Subject: **Response to Portion of NRC Request for Additional Information Letter No. 321 Related to the ESBWR Design Certification – Containment Systems – RAI Number 6.2-193 S01**

**Response to Portion of NRC Request for  
Additional Information Letter No. 321  
Related to ESBWR Design Certification Application**

**Containment Systems**

**RAI Number 6.2-193 S01**

Figure RAI 6.2-193S01- 1 Comparison of System Pressures for DCD Rev. 5 Appendix 6I Limiting Case and Current Analysis.

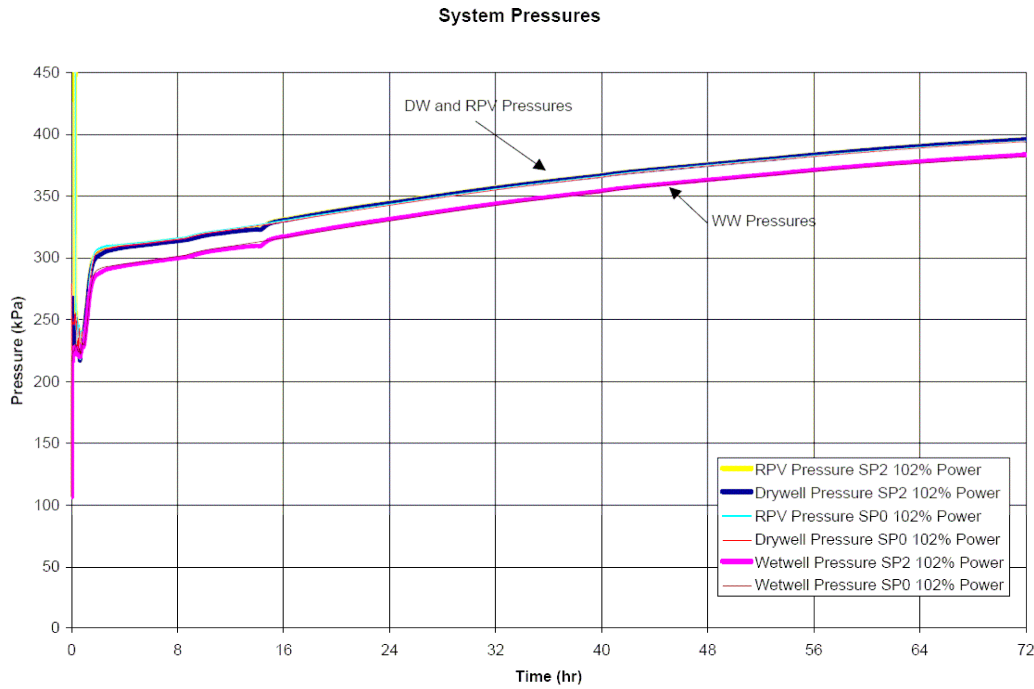
*Describe the effect of increased drywell-to-wetwell bypass leakage and increased amount of feedwater flowing into the containment on the SP2 analyses.*

response. Figure 6.2-193S01-1 illustrates that the differences in containment pressure response between the two scenarios is similar to the difference reported in the original response. Furthermore, Figure 6.2-193S01-2 shows that the difference in Total Power and PCCS Power are not noticeable.

The results of this analysis support the original findings reported in the response to RAI 6.2-193; the elevated FW temperature associated with SP2 does not have an appreciable effect on long-term containment pressure.
